## **Staff Changes**

This section covers changes proposed by Planning Staff to correct errors and to reflect changes in conversion philosophy based on discussions with the PHED Committee and the Planning Board.

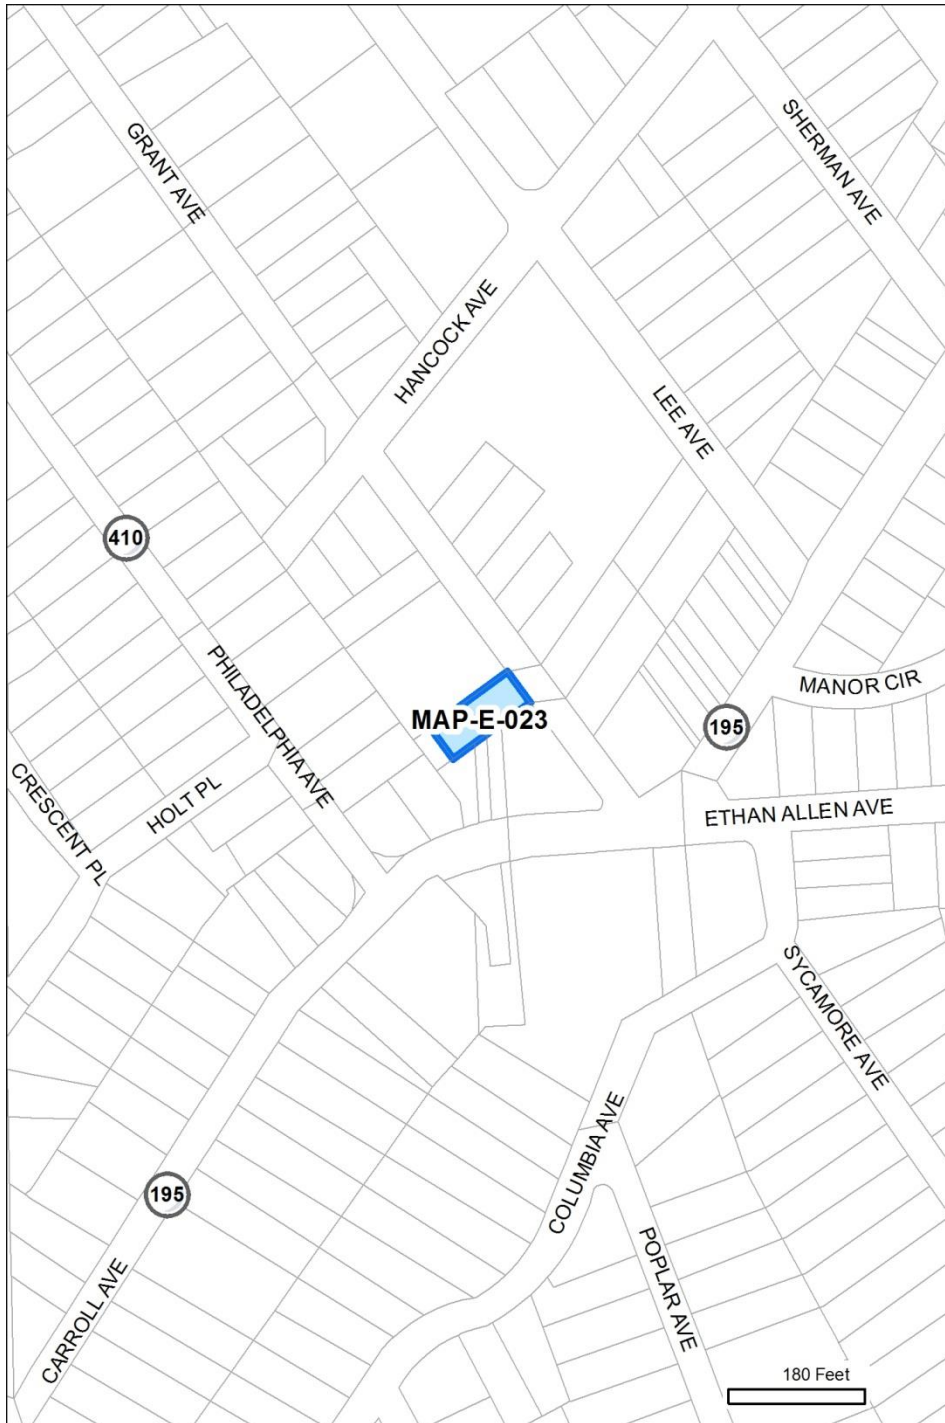
<b>Unique ID:</b> MAP-E-023		staff rec. change
<b>Master Plan ID:</b> 6		
<b>Master Plan:</b>	Takoma Park	
<b>Location:</b>	Grant Ave	
<b>Existing Zone:</b>	O-M	
<b>Proposed Conv:</b> (5/2)	EOF-1.0 H-50	
<b>Prop. Revised Conv:</b>	EOF-1.5 H-50	
<b>Category:</b>	Staff Error	
<b>Modifications</b>	<b>Zone Group:</b>	No change
	<b>Overall FAR:</b>	Increased to 1.5
	<b>Comm'l FAR:</b>	-
	<b>Resid'l FAR:</b>	-
	<b>Height:</b>	No change
<b>Reason for change:</b>		
<p><i>The standard conversion for O-M parcels is an FAR of 1.5; the density currently allowed. In the 5/2 conversion, stafferred in giving this conversion a 1.0 FAR.</i></p>

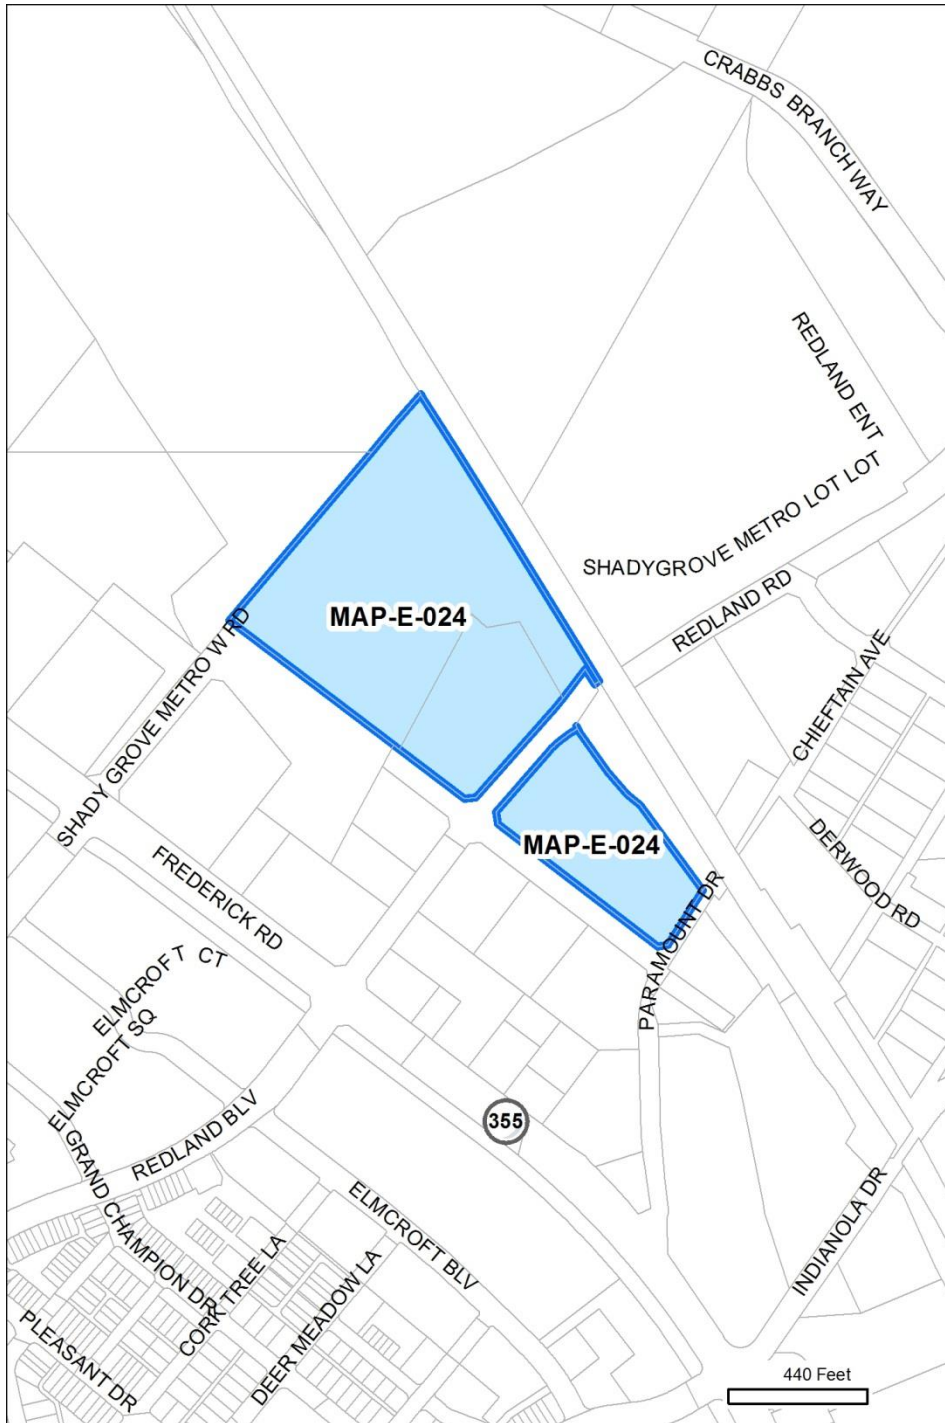
<b>Unique ID:</b> MAP-E-024		staff rec. change
<b>Master Plan ID:</b> 8		
<b>Master Plan:</b>	Shady Grove	
<b>Location:</b>	N and E corners of Redland and Somerville	
<b>Existing Zone:</b>	TOMX-2/TDR	
<b>Proposed Conv: (5/2)</b>	CR-1.75 C-0.5 R-1.5 H-160 T	
<b>Prop. Revised Conv:</b>	CR-2.0 C-0.5 R-1.5 H-160 T	
<b>Category:</b>	Staff Error	
<b>Modifications</b>	<b>Zone Group:</b>	No change
	<b>Overall FAR:</b>	Increased to 2.0
	<b>Comm'l FAR:</b>	No change
	<b>Resid'l FAR:</b>	No change
	<b>Height:</b>	No change
<b>Reason for change:</b>		
<p>The 5/2 conversion was made in error. The Master Plan recommends a base density of 1.75 FAR, but allows up to 2.0 FAR overall with TDRs. Therefore, the overall FAR should be increased to 2.0.</p>

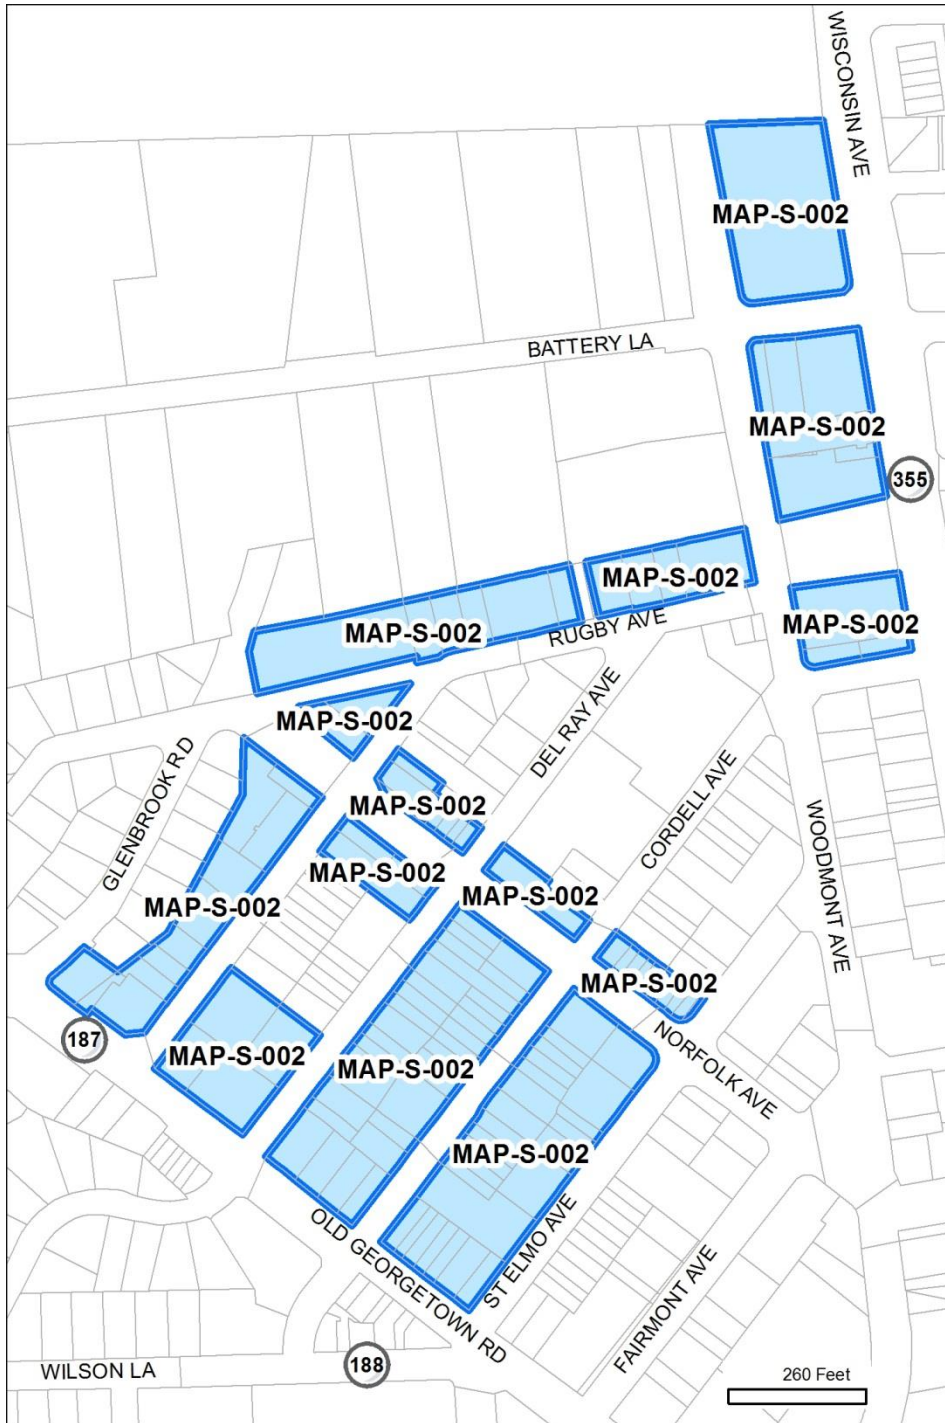
<b>Unique ID:</b> MAP-S-002		staff rec. change
<b>Master Plan ID:</b> 1 & 2		
<b>Master Plan:</b>	Woodmont Triangle	
<b>Location:</b>	Woodmont Triangle Plan Area:	
<b>Existing Zone:</b>	CBD-1	
<b>Proposed Conv:</b> (5/2)	CR-3.0 C-2.0 R-2.5 H-110 T	
<b>Prop. Revised Conv:</b>	CR-3.0 C-1.0 R-2.5 H-90 T	
<b>Category:</b>	Staff Error	
<b>Modifications</b>	<b>Zone Group:</b>	No change
	<b>Overall FAR:</b>	No change
	<b>Comm'l FAR:</b>	Reduced to 1.0
	<b>Resid'l FAR:</b>	No change
	<b>Height:</b>	Reduced to 90'
<b>Reason for change:</b>		
<p><i>The Master Plan recommends limiting FAR to 1.0 for non-residential uses. The 5/2 conversion gave 2.0 (the statutory limit) in error.</i></p> <p><i>The 5/2 conversion called for 110' in height. This height represents an increase recommended in the Master Plan but only for additional MPDUs. Staff revised the text for the "T" designation – allowing for additional height only for MPDUs, retaining the statutory 90' height.</i></p>

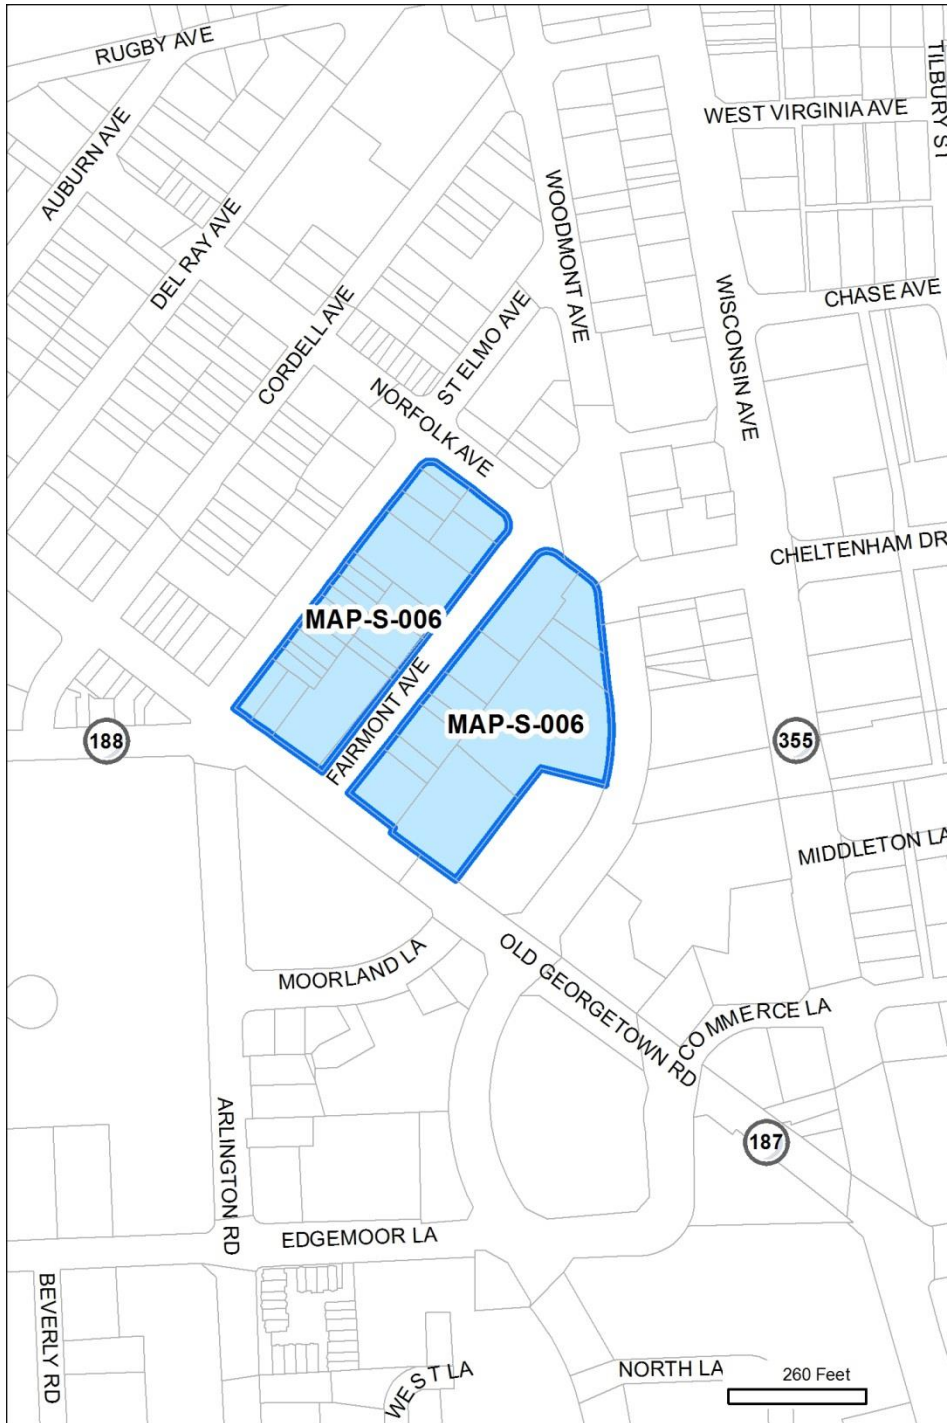
<b>Unique ID:</b> MAP-S-006		staff rec. change
<b>Master Plan ID:</b> 6		
<b>Master Plan:</b>	Woodmont Triangle	
<b>Location:</b>	Blocks on either side of Fairmont between Old Georgetown & Norfolk	
<b>Existing Zone:</b>	CBD-R2	
<b>Proposed Conv:</b> (5/2)	<del>CR-5.0 C-1.0 R-4.5 H-175 T</del>	
<b>Prop. Revised Conv:</b>	CR-5.0 C-1.0 R-4.5 H-145 T	
<b>Category:</b>	Staff Recommendation	
<b>Modifications</b>	<b>Zone Group:</b>	No change
	<b>Overall FAR:</b>	No change
	<b>Comm'l FAR:</b>	No change
	<b>Resid'l FAR:</b>	No change
	<b>Height:</b>	Decreased to 145'
<b>Reason for change:</b>		
<p><i>The Master Plan recommended a height of 174' on these parcels, however it recommended that height over 143' only be allowed with more than 22% MPDUs.</i></p> <p><i>The 5/2 conversion set the height at 175' to allow the MPDU height. However, staff now recommends limiting the mapped height to 145'. Staff has modified the "T" designation language to allow the additional height only for MPDUs.</i></p>

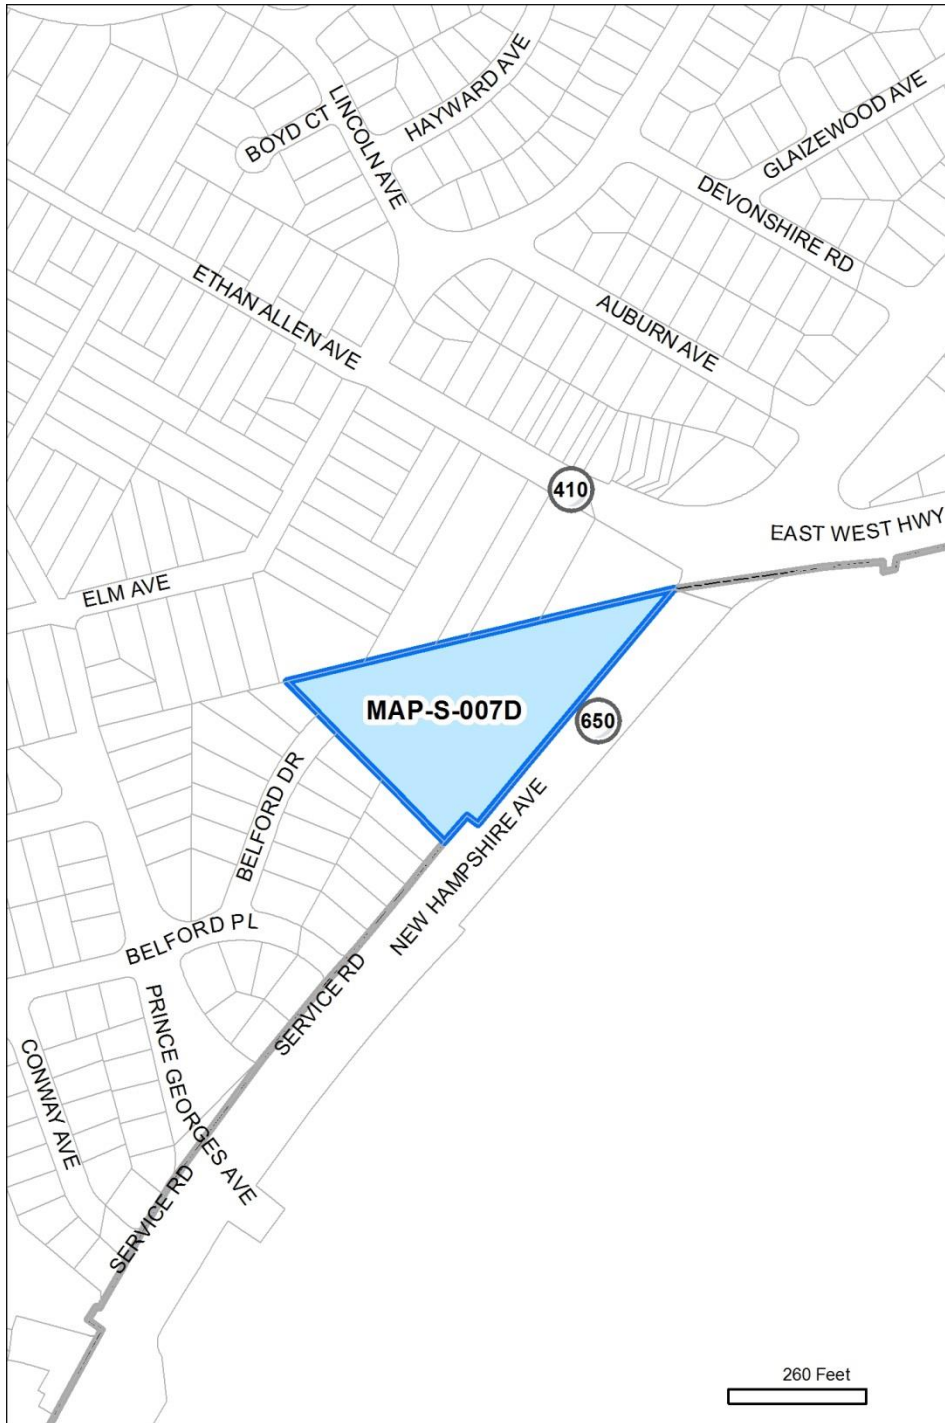
<b>Unique ID:</b> MAP-S-007D		staff rec. change
<b>Master Plan ID:</b> n/a		
<b>Master Plan:</b>	Takoma Park	
<b>Location:</b>	SW corner New Hampshire & East-West Hwy	
<b>Existing Zone:</b>	C-2	
<b>Proposed Conv:</b> (5/2)	CRT-1.5 C-1.5 R-1.0 H-45	
<b>Prop. Revised Conv:</b>	CRT-1.5 C-1.5 R-0.75 H-45	
<b>Category:</b>	Staff Recommendation	
<b>Modifications</b>	<b>Zone Group:</b>	No change
	<b>Overall FAR:</b>	No change
	<b>Comm'l FAR:</b>	No change
	<b>Resid'l FAR:</b>	Reduced to 0.75
	<b>Height:</b>	No change
<b>Reason for change:</b>		
<p>Since the 5/2 conversion, further staff analysis indicated that residential development in the C-2 zone is essentially limited to around 0.75 FAR. As a result, the Planning Board recommended reducing allowed residential FAR to 0.75, following its review of DMA-956. The PHED Committee agrees with this recommendation.</p>

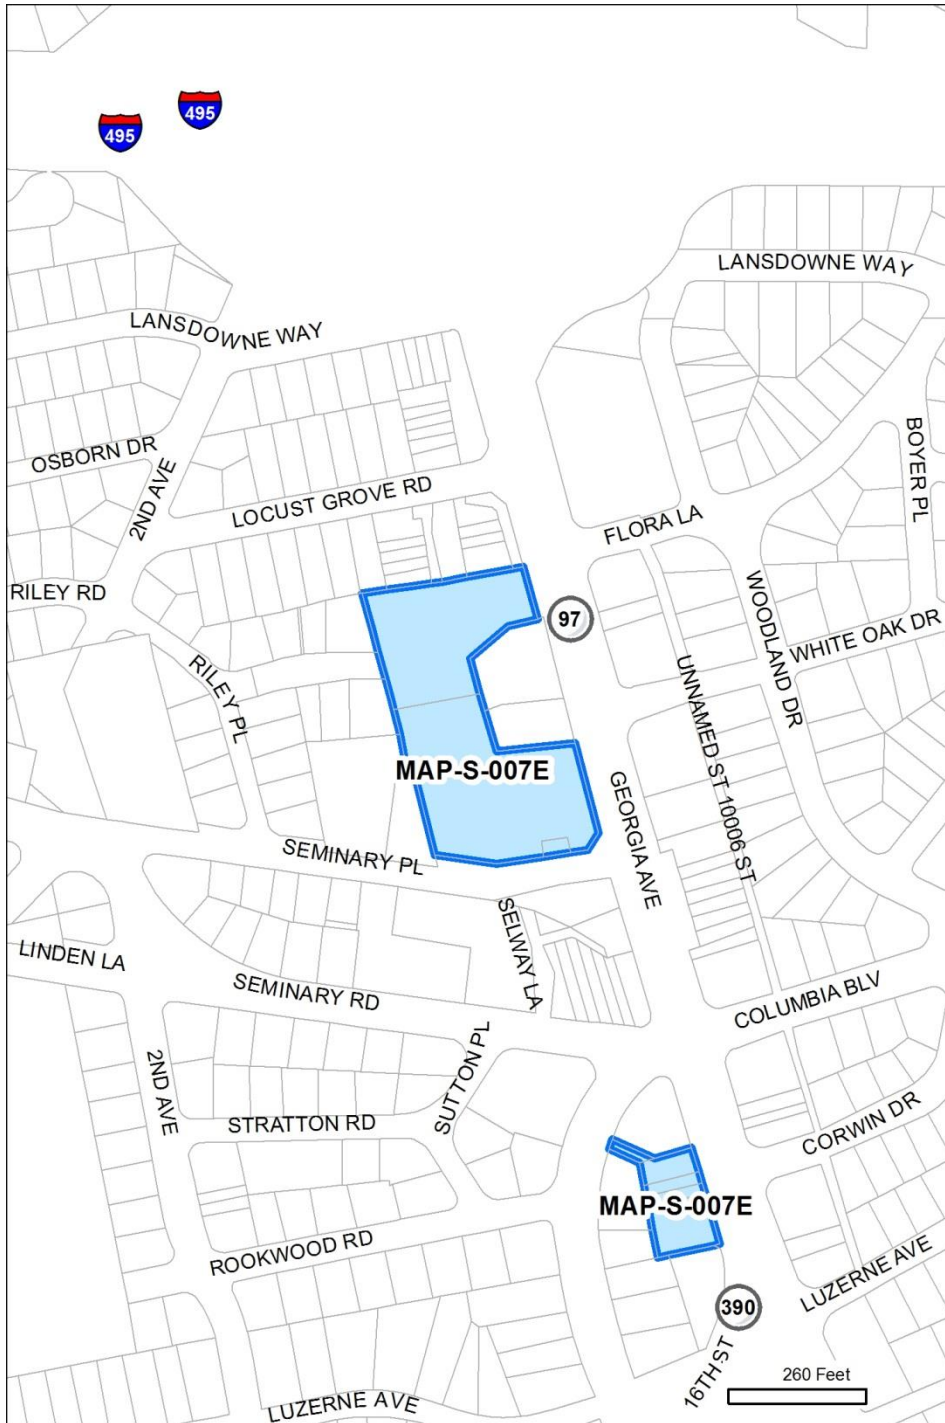
<b>Unique ID:</b> MAP-S-007E		staff rec. change
<b>Master Plan ID:</b> n/a		
<b>Master Plan:</b>	North and West Silver Spring	
<b>Location:</b>	Montgomery Hills	
<b>Existing Zone:</b>	C-2	
<b>Proposed Conv:</b> (5/2)	CRT-1.5 C-1.5 R-1.0 H-45	
<b>Prop. Revised Conv:</b>	CRT-1.5 C-1.5 R-0.75 H-45	
<b>Category:</b>	Staff Recommendation	
<b>Modifications</b>	<b>Zone Group:</b>	No change
	<b>Overall FAR:</b>	No change
	<b>Comm'l FAR:</b>	No change
	<b>Resid'l FAR:</b>	Reduced to 0.75
	<b>Height:</b>	No change
<b>Reason for change:</b>		
<p>Since the 5/2 conversion, further staff analysis indicated that residential development in the C-2 zone is essentially limited to around 0.75 FAR. As a result, the Planning Board recommended reducing allowed residential FAR to 0.75, following its review of DMA-956. The PHED Committee agrees with this recommendation.</p>

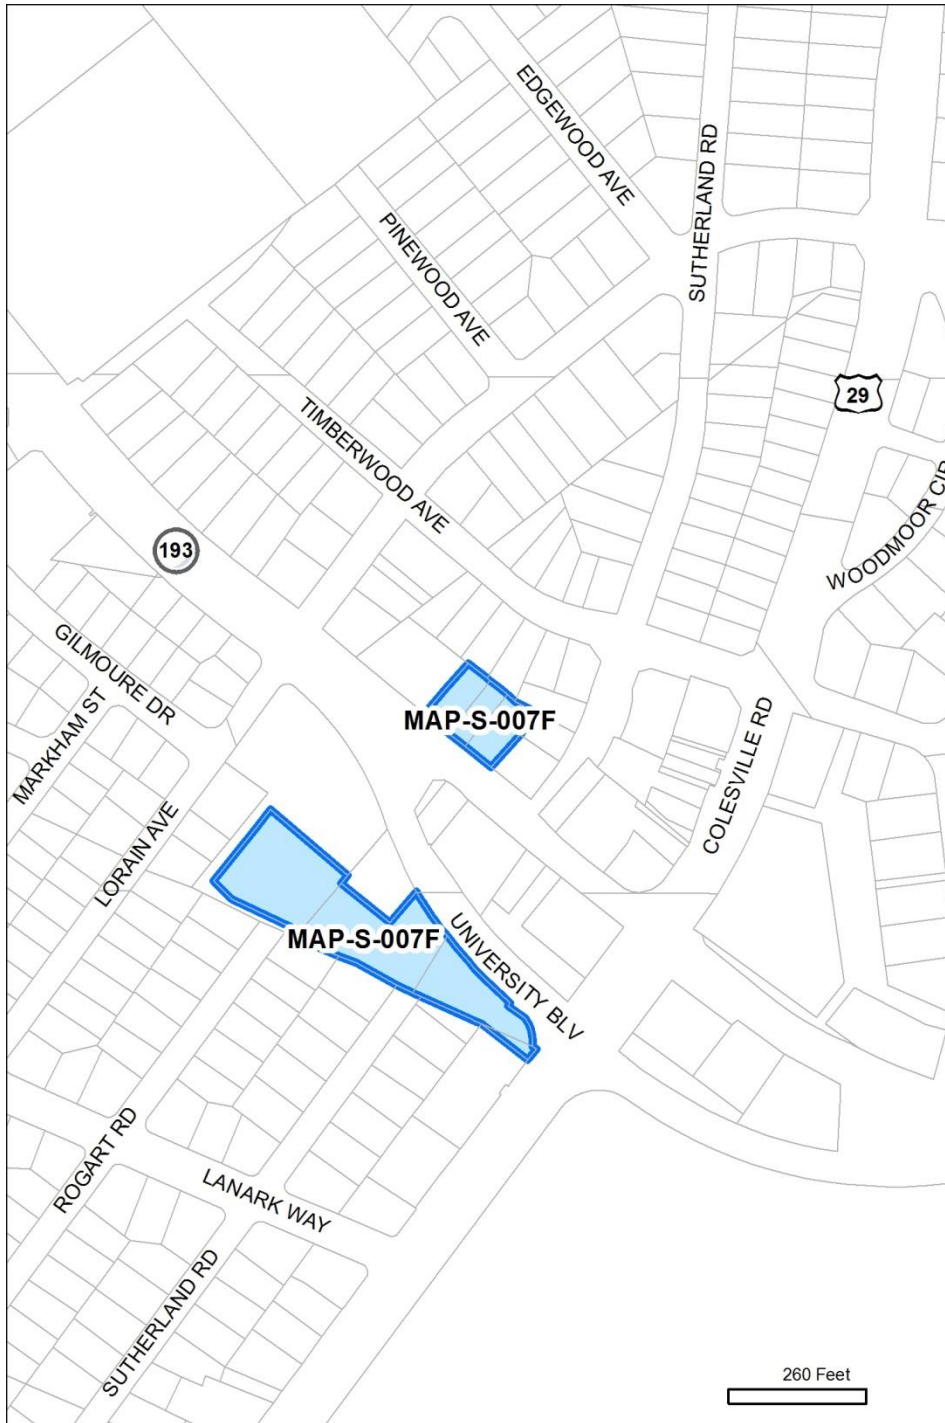
<b>Unique ID:</b> MAP-S-007F		staff rec. change
<b>Master Plan ID:</b> n/a		
<b>Master Plan:</b>	Four Corners	
<b>Location:</b>	Four Corners	
<b>Existing Zone:</b>	C-2	
<b>Proposed Conv: (5/2)</b>	CRT-1.5 C-1.5 R-1.0 H-45	
<b>Prop. Revised Conv:</b>	CRT-1.5 C-1.5 R-0.75 H-45	
<b>Category:</b>	Staff Recommendation	
<b>Modifications</b>	<b>Zone Group:</b>	No change
	<b>Overall FAR:</b>	No change
	<b>Comm'l FAR:</b>	No change
	<b>Resid'l FAR:</b>	Reduced to 0.75
	<b>Height:</b>	No change
<b>Reason for change:</b>		
<p>Since the 5/2 conversion, further staff analysis indicated that residential development in the C-2 zone is essentially limited to around 0.75 FAR. As a result, the Planning Board recommended reducing allowed residential FAR to 0.75, following its review of DMA-956. The PHED Committee agrees with this recommendation.</p>
